NOTICE OF DECISION

Friendsview Springbrook Meadows II – Design Review – DR220-0005

<p>DECISION AND FINDINGS Friendsview Springbrook Meadows II – Design Review – DR220-0005</p>

REQUEST: Design Review of an independent senior living community consisting of 14 duplex units and expansion of an existing Community Center building

PHASE 4: CONCEPTUAL BUILDING OUTLINE ALONG WITH DRIVE TO TRASH ENCLOSURE, SIDEWALK, AND PARKING AREA SHOWN.

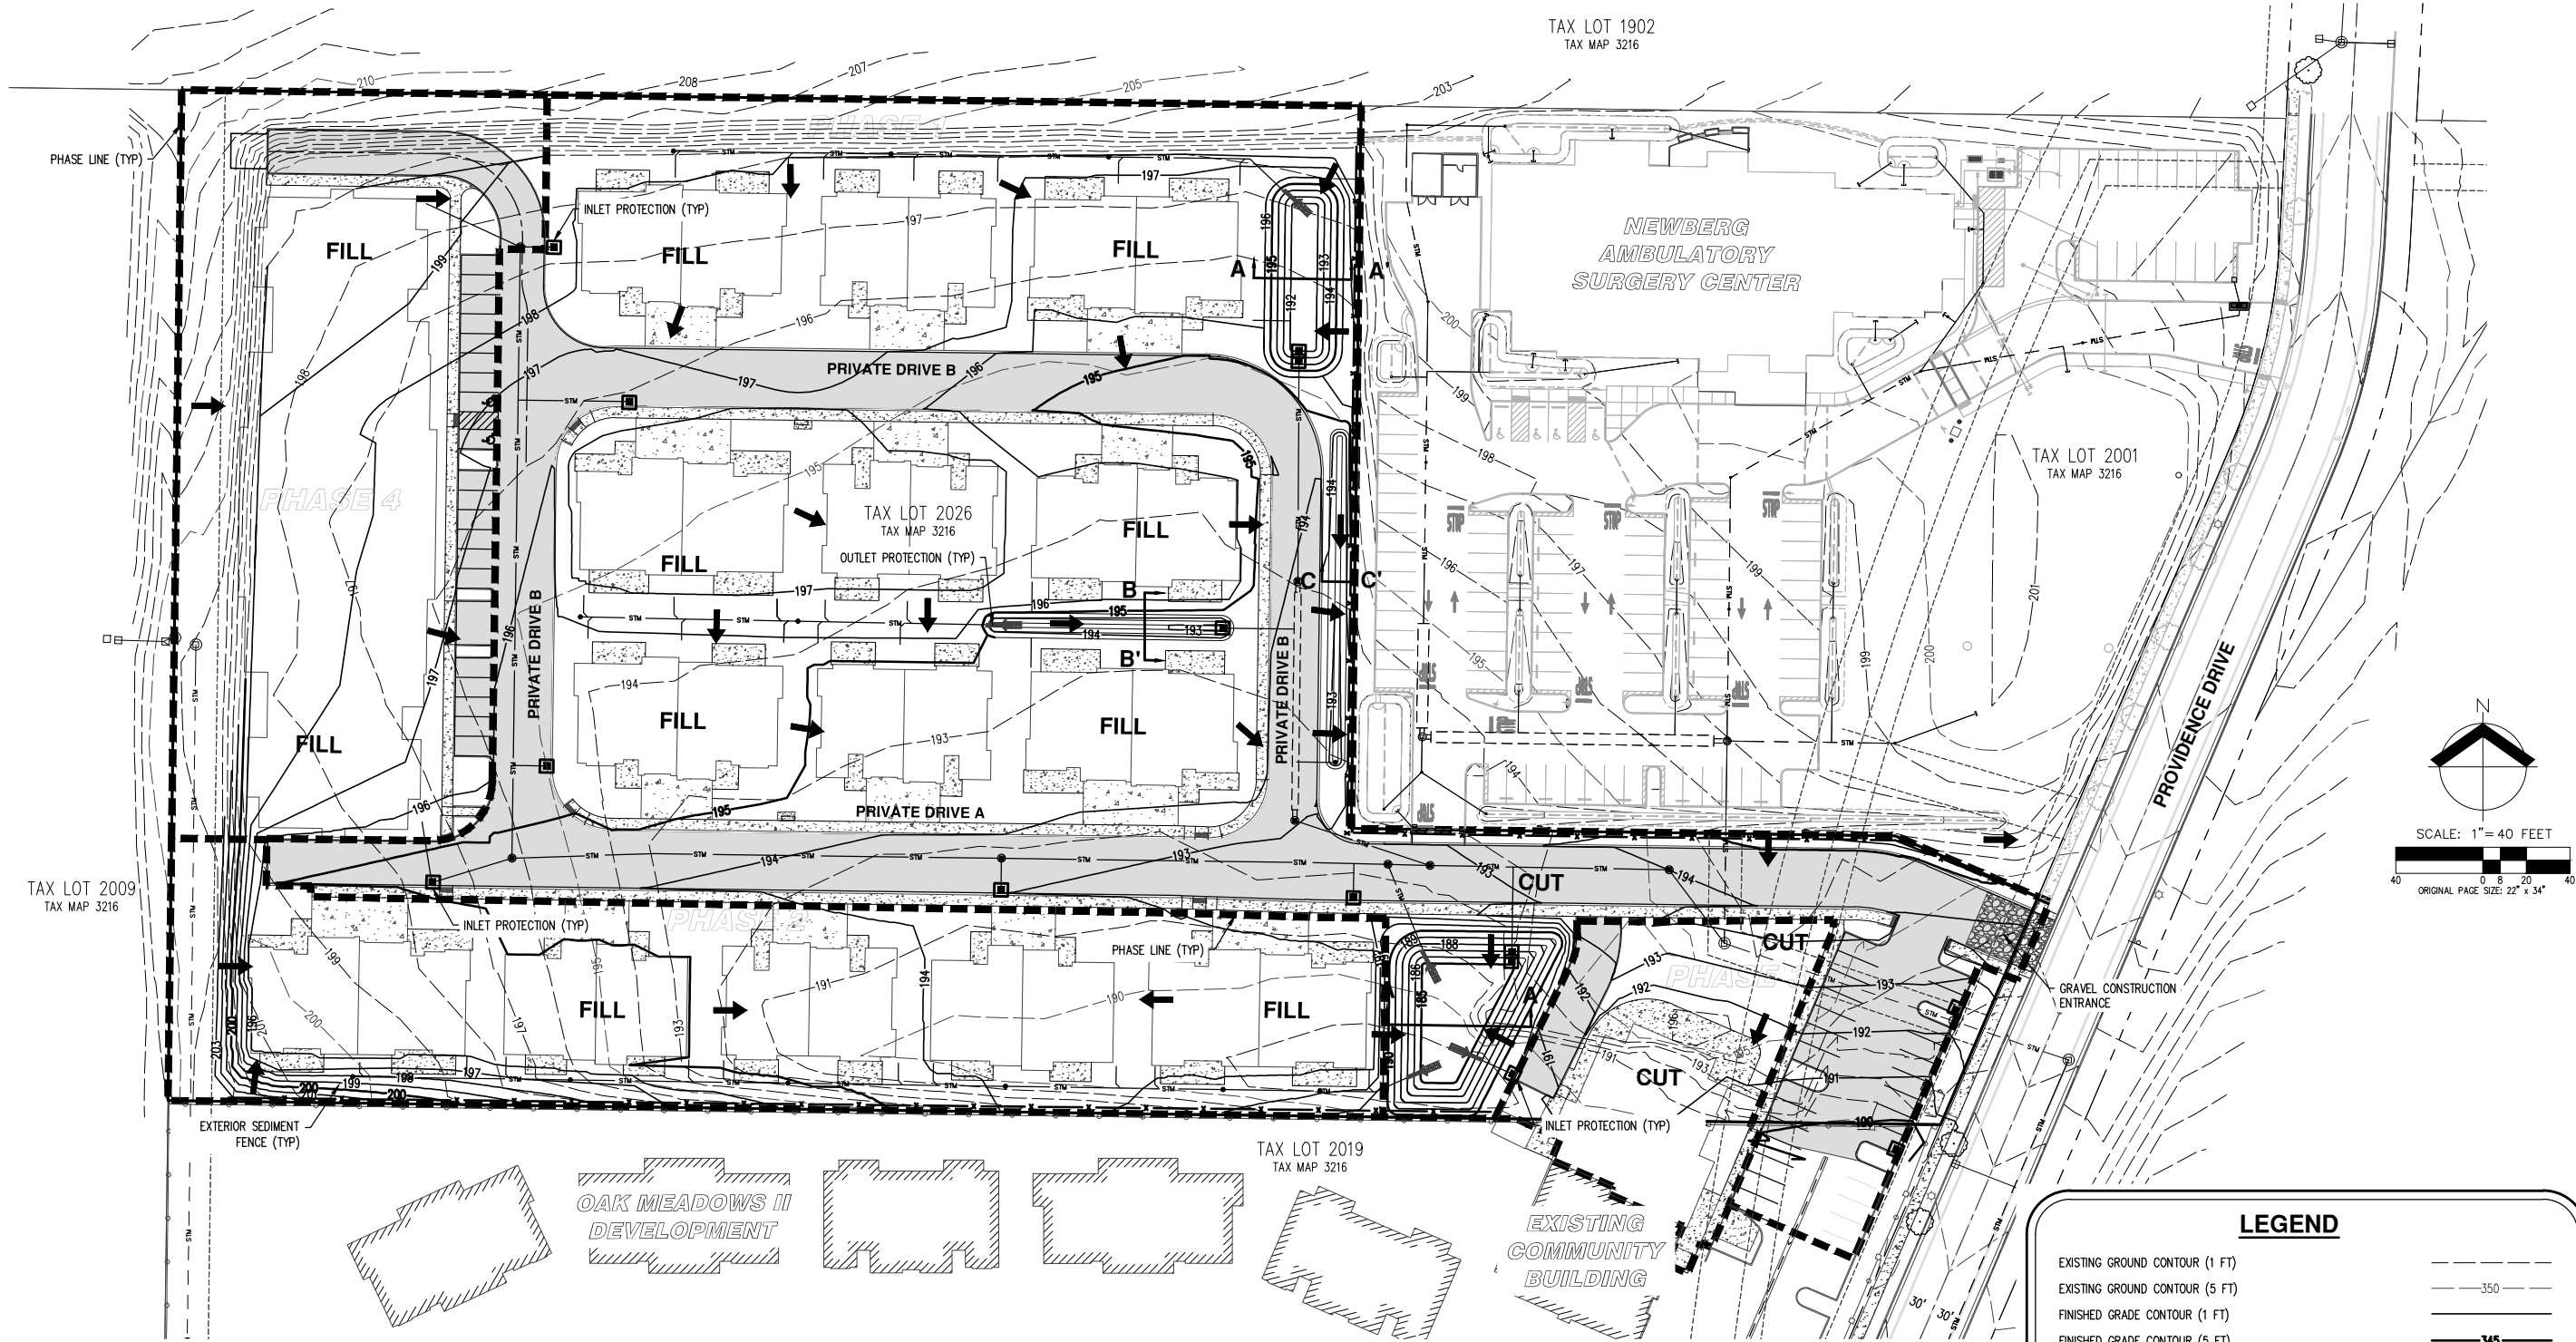
Sheet P04 of the applicants' plans shows four phases of development, with the first three phases being reviewed for this design review application. The development will construct a looped private driveway for internal vehicle circulation as part of Phase 1 construction. Both Phases 1 and 2 will involve construction of the duplexes. Phase 3 will involve expansion of the existing community building over the consolidated property line, land use file PLC20-0004, along with sidewalk and 17 additional parking spaces along the eastern portion of the development site. The applicant has also stated in their narrative that one side of the private looped driveway will allow on-street parking. Plan Sheet P06 shows a 24 foot drive aisle, parking spaces dimensioned at 9 feet by 18 feet facing toward N Providence Drive and 9 feet by 20 feet on the west side of the drive aisle for the Community Center.

SITE PLAN - LIGHTING

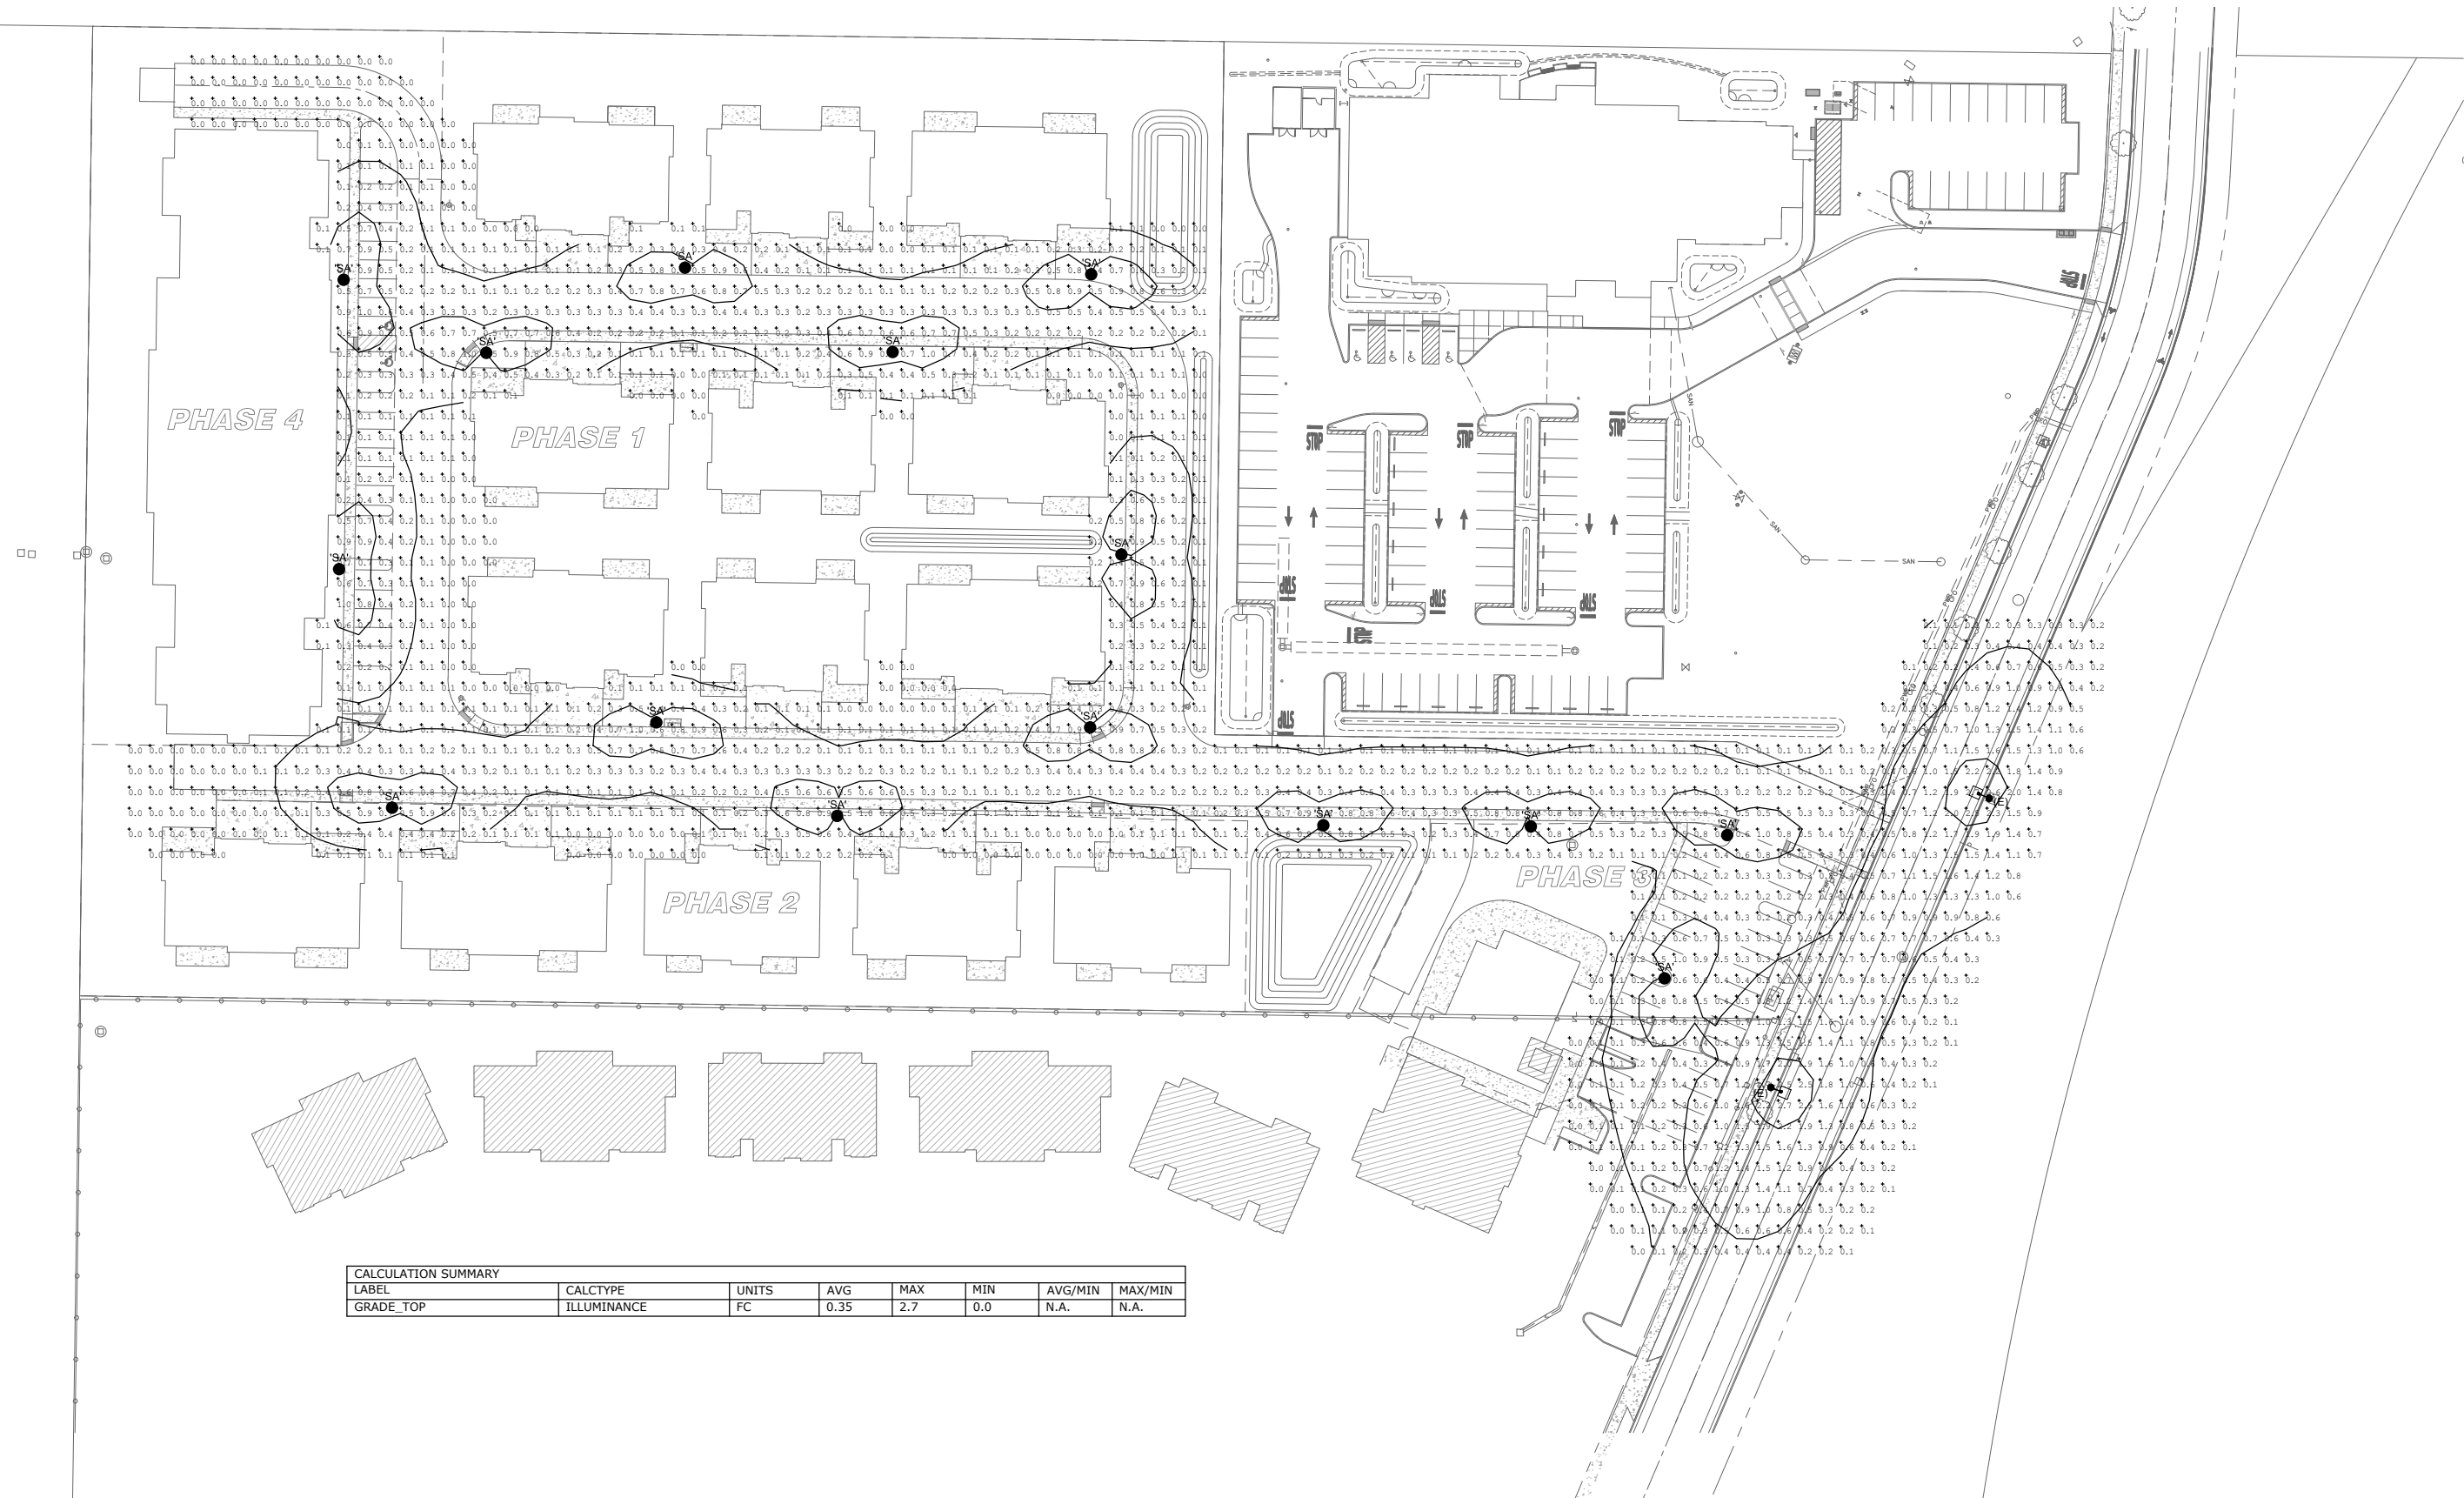
Finding: Sheet L1 and L2 show sidewalks, planter strip with two Shumard Oak street trees along N Providence Drive. Sheets E1.0 and EPH1.0 demonstrate compliance with pedestrian scale lighting requirements. The applicant is not proposing any street furniture with this application. ADA requirements are discussed in detail in a separate section of this report and Conditions of Approval 2.a. and 2.b. require the applicant to meet ADA requirements. The two Shumard Oak trees, lawn or grass groundcover is being proposed in the planter strip along N Providence Drive in compliance with this section of the NMC. Other areas throughout the site will be planted with additional street trees, ground cover and shrubs in compliance with this section of the NMC. The applicants' narrative states that the "required landscaping installed as
